ITEM FOR ENVIRONMENTAL COMMISSION AGENDA

NAME & NUMBER OF PROJECT: Oltorf Site Plan (SP-2021-0091C)

REQUEST: Variance request is as follows:
Request to vary from LDC 25-8-301 to allow driveways on slopes over 15%.
Request to vary from LDC 25-8-341 to allow cut over 4 feet up to 8 feet.
Request to vary from LDC 25-8-342 to allow fill over 4 feet up to 20.5 feet.

**Variance Requests from LDC 25-8-301, LDC 25-8-341 and LDC 25-8-342
Associated with SP-2021-0091C, 4544 E Oltorf**

EXISTING SLOPE MAP

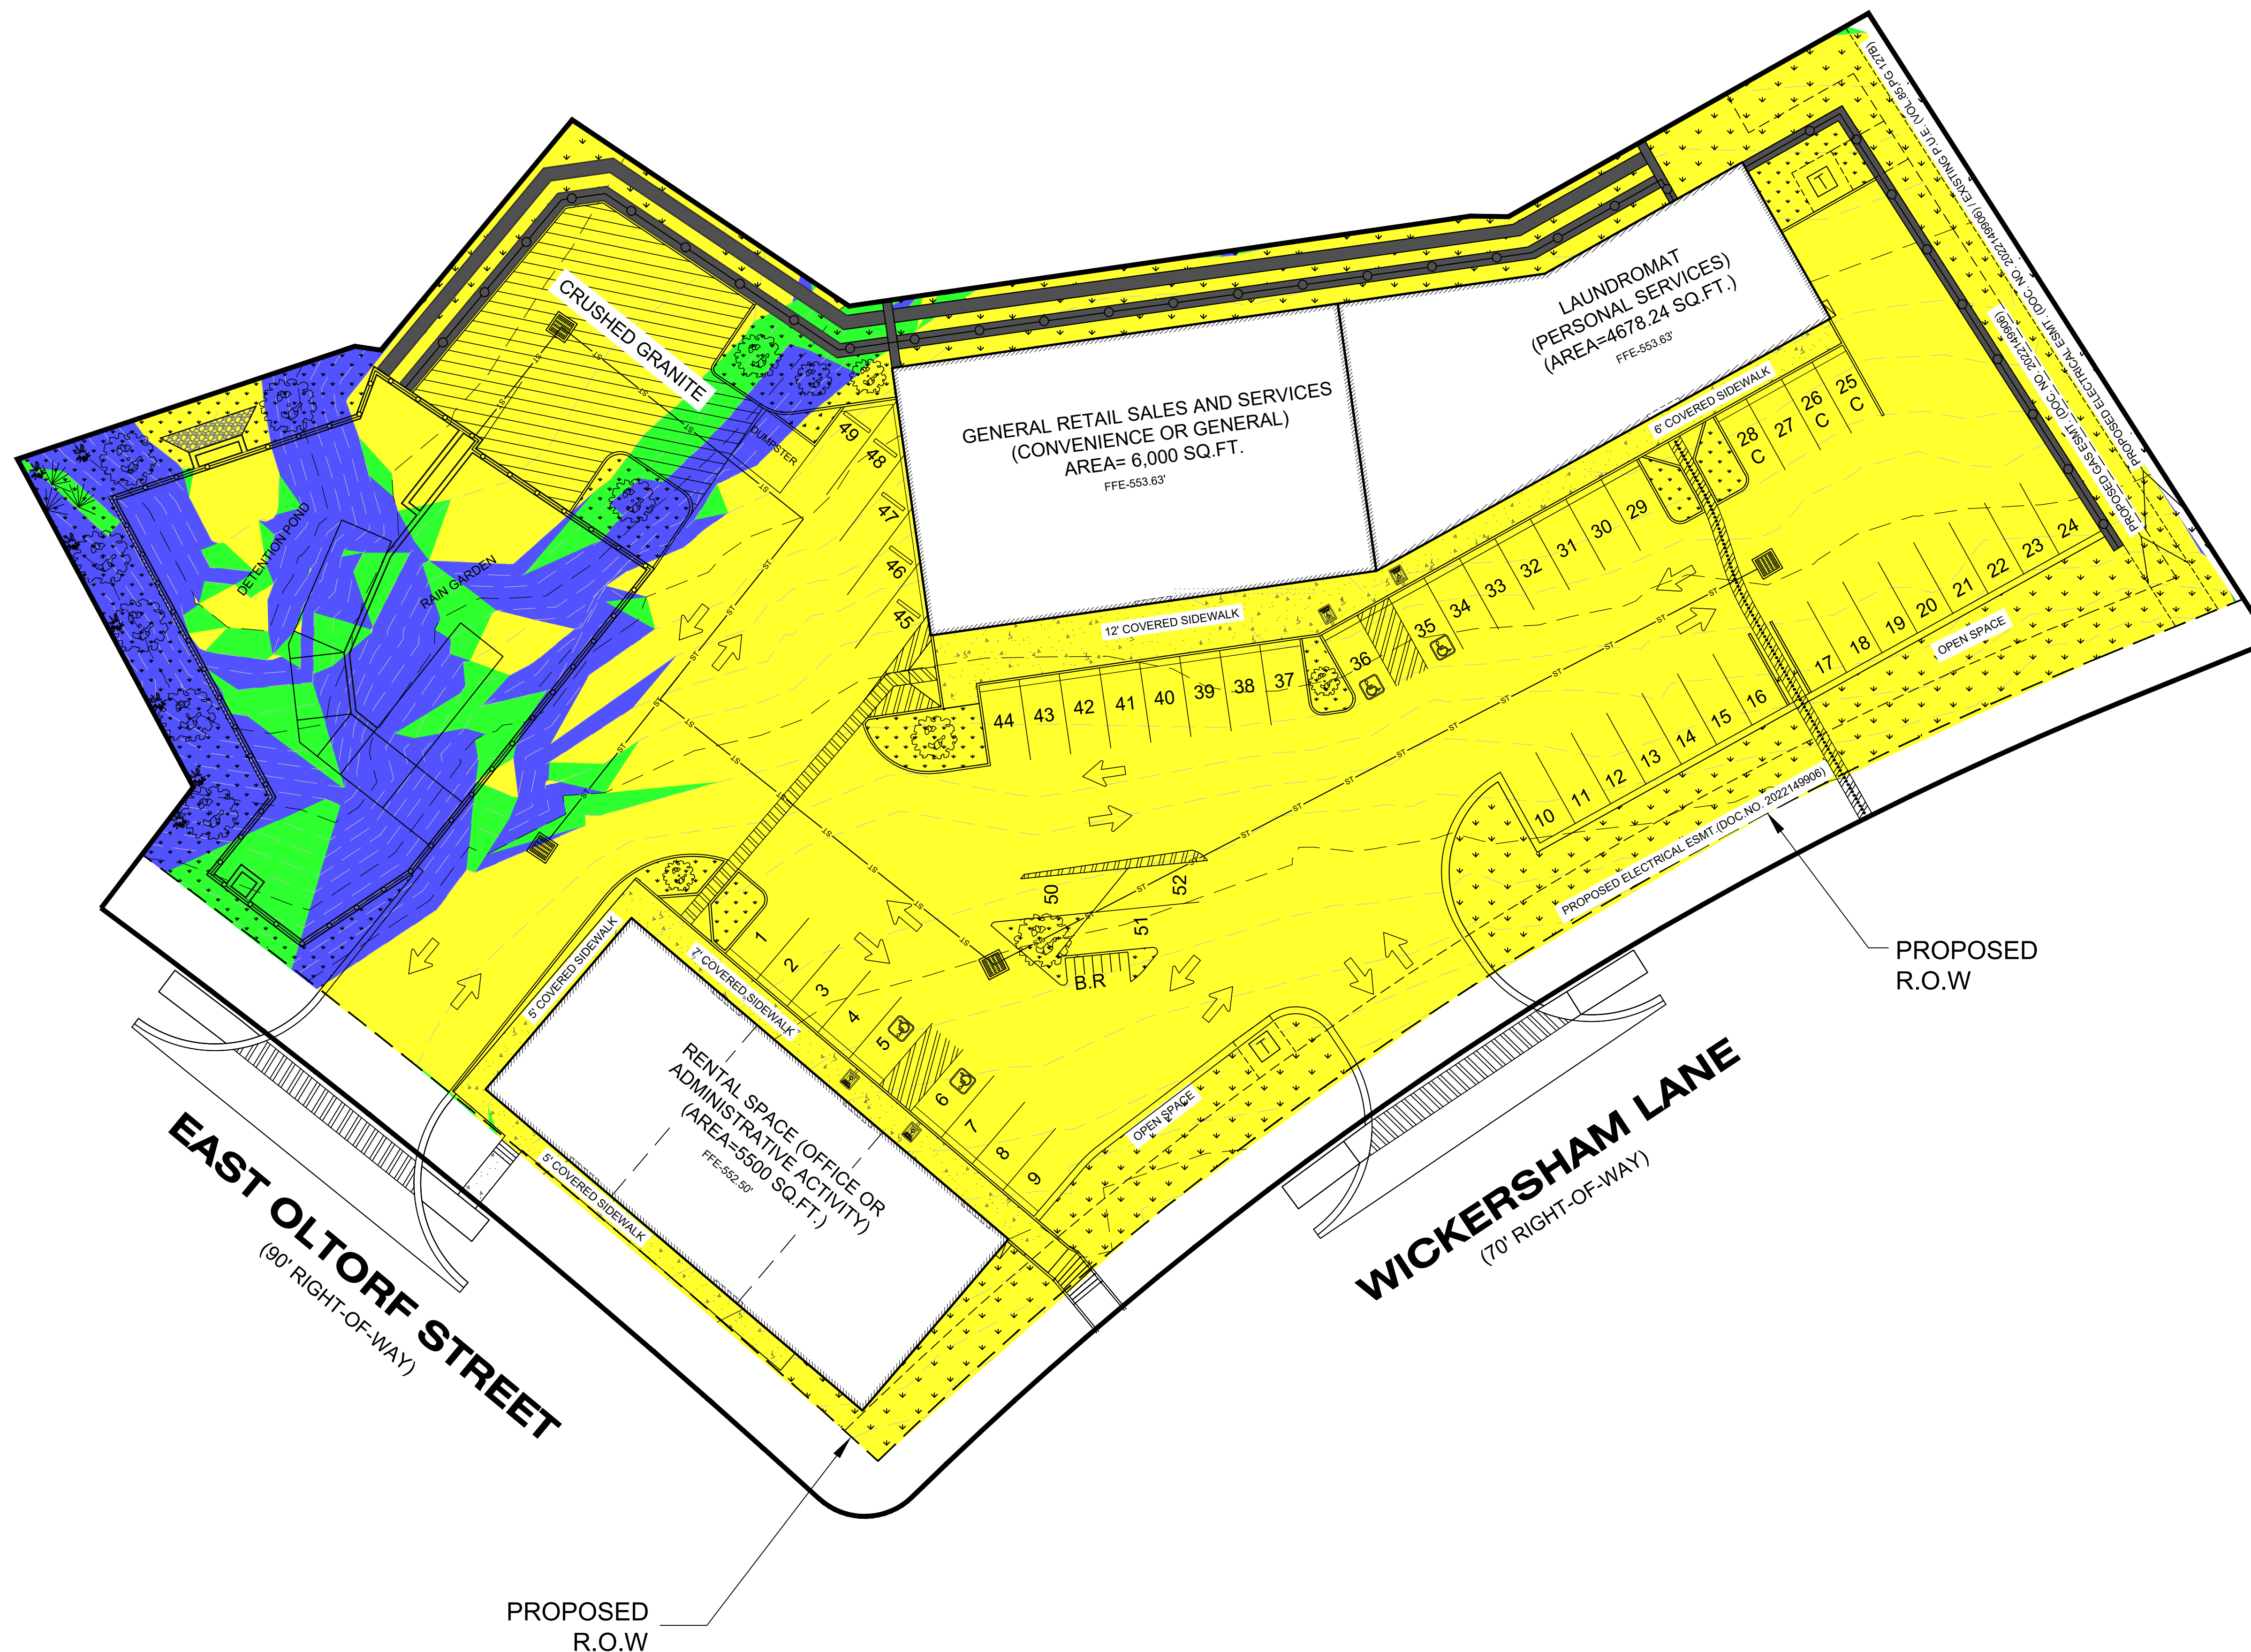
Yes. The variance will not be providing a special privilege to the applicant. The proposed buildings are similar in size to similarly situated property. Because the property is also subject to Austin's Commercial Design Standards Ordinance, 40% of the roadway frontage along East Oltorf is required to have building frontage adjacent to the right of way, therefore, the only available driveway access from Oltorf must cross existing slopes which are steeper than 15% gradient

Yes. Existing site conditions and accessibility regulations require the only available driveway access from Oltorf to cross existing slopes that exceed 15% gradient.

CUT/FILL EXHIBIT

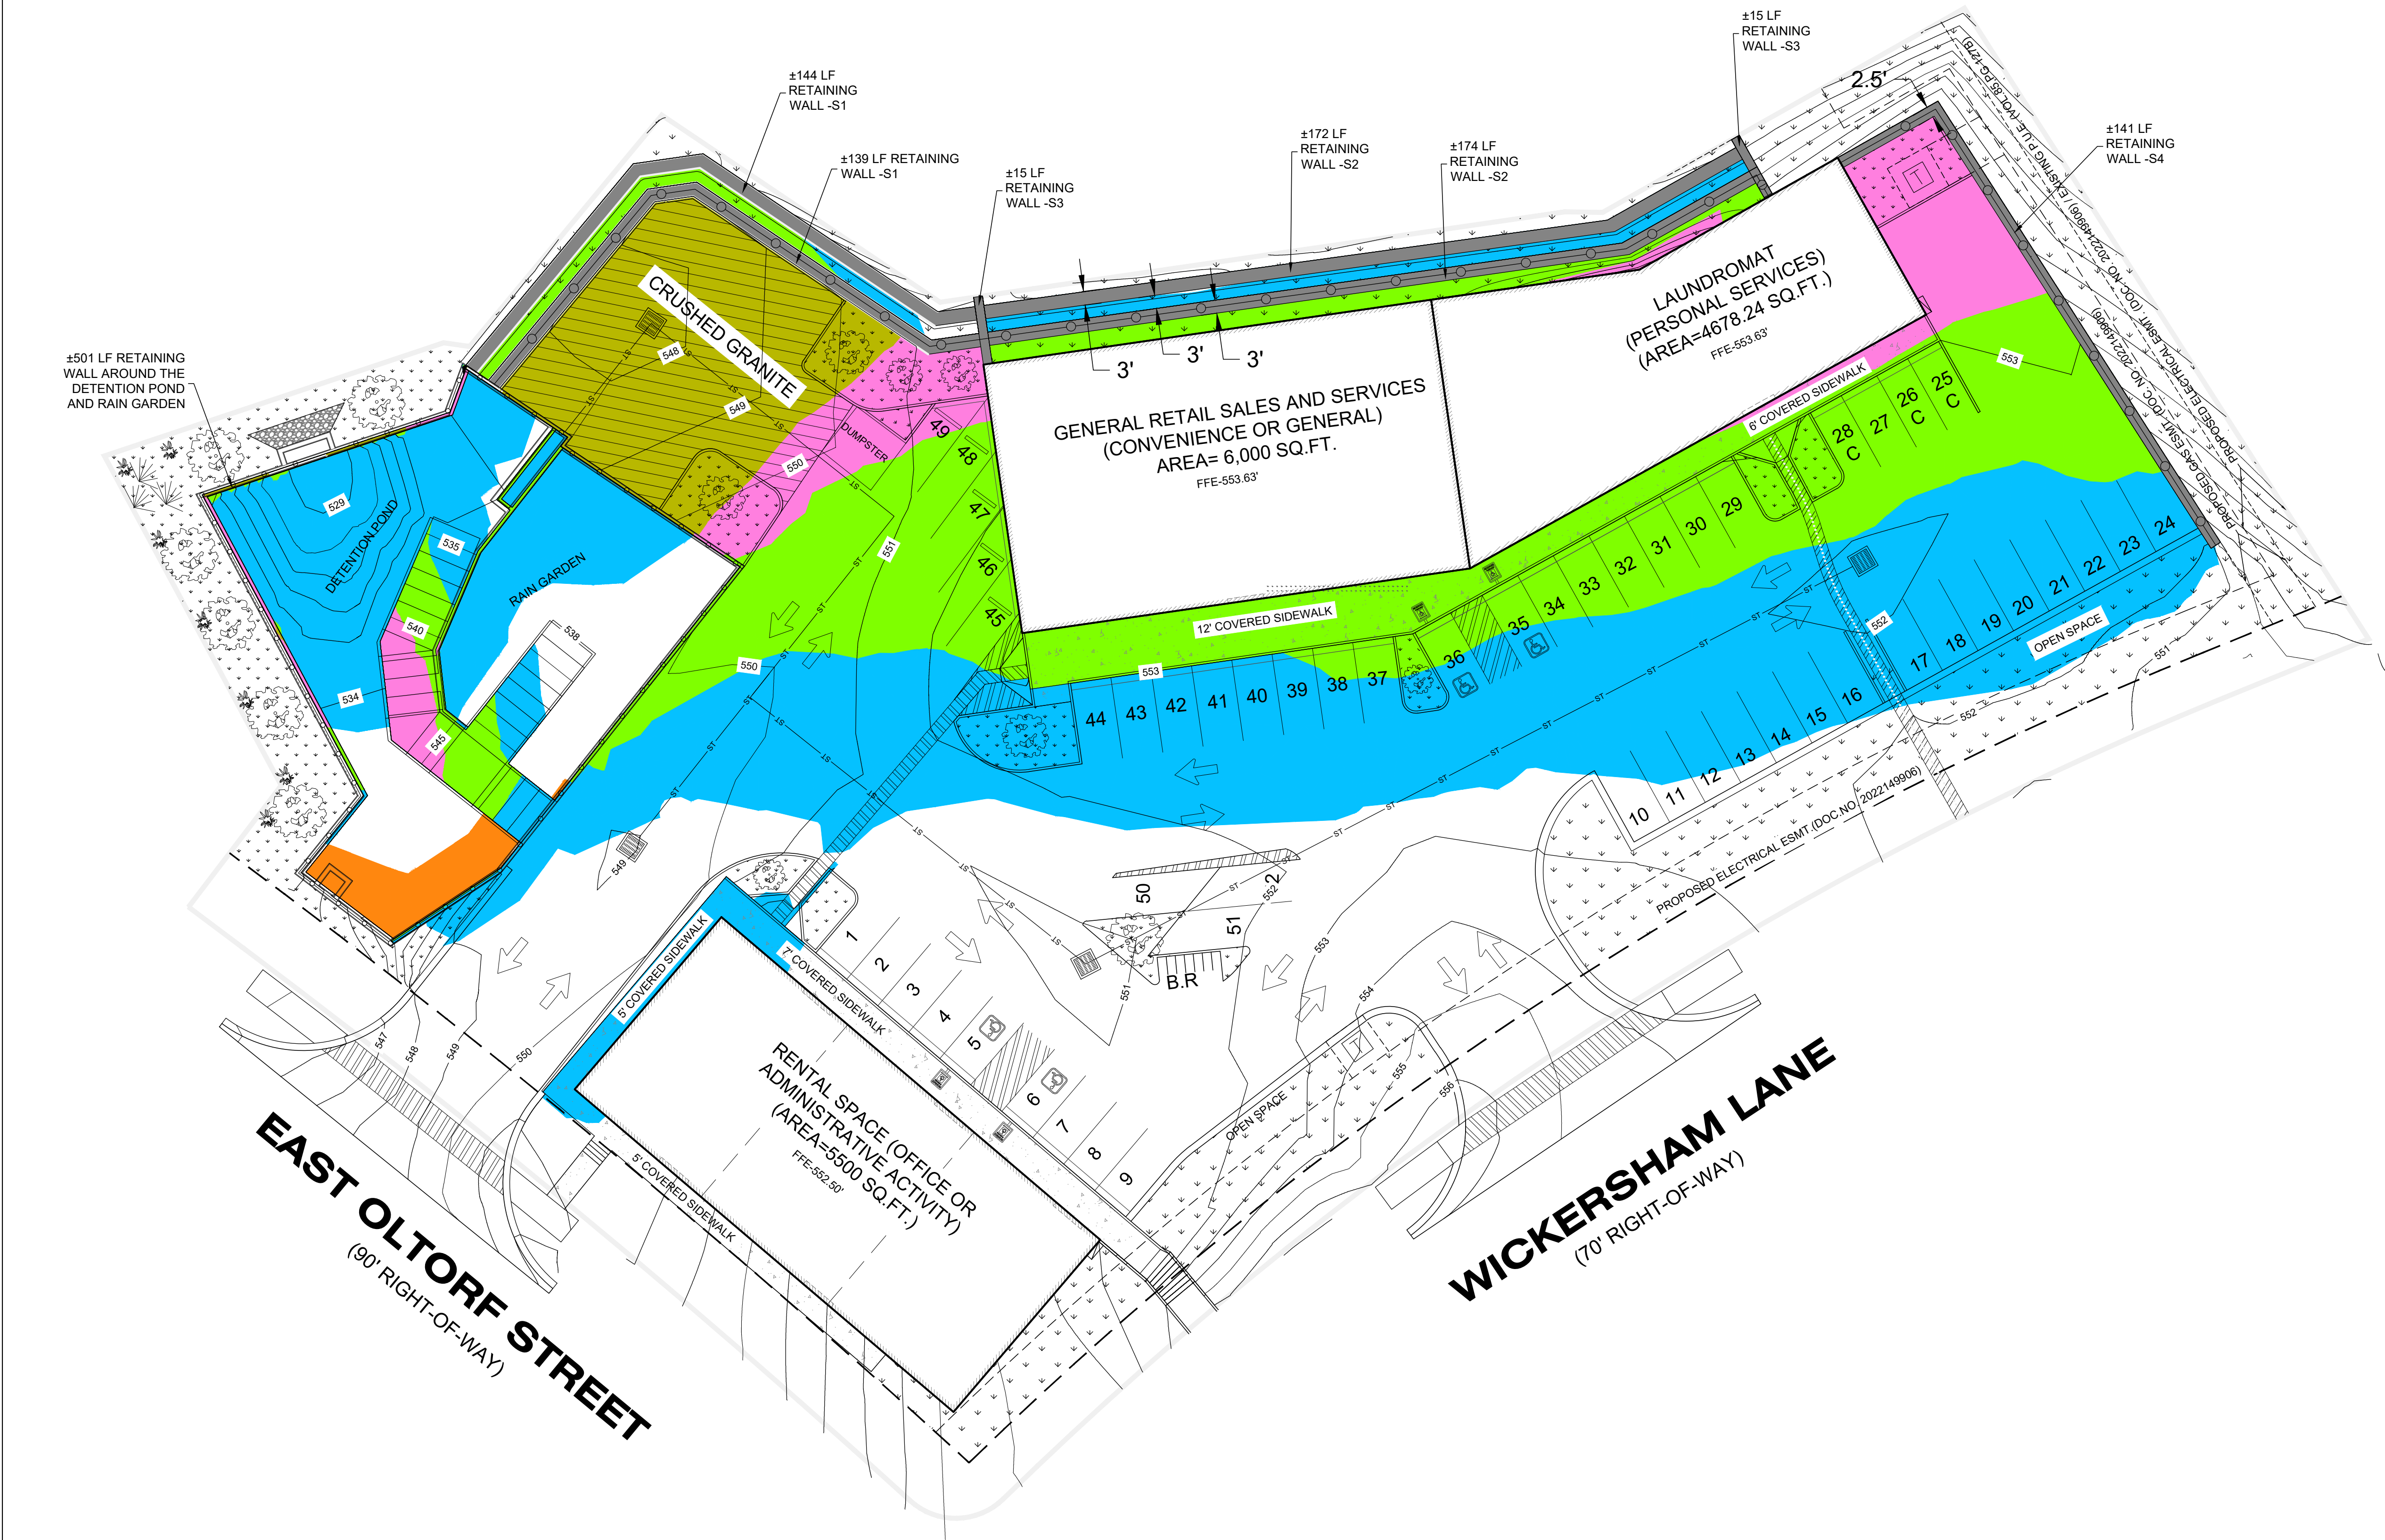
In order to facilitate this type of drainage which will require stormwater releases from detention ponds to flow into the storm sewer pipes along East Oltorf, grading within the detention/water quality area will have cut up to 8 feet and fill up to 20.5 feet.

outflows from the site; this requires us to grade approximately 435 square feet within the detention pond area of the site with cuts ranging between 4 and 8 feet, and to fill approximately 30,006 square feet of the site with depths of 4 to 12 feet, and to fill approximately 5,663 square feet of the site with fill to depths of 12 to 20.5 vertical feet. Significant redesigns were done in accordance with recommendations from Environmental staff, to eliminate vehicle parking spaces over original site slope gradients exceeding 15%, and to eliminate additional driveways on slopes over 15%.

- Provide 8 additional trees at 3 caliper inches.
- Provide structural containment of fill with retaining walls.
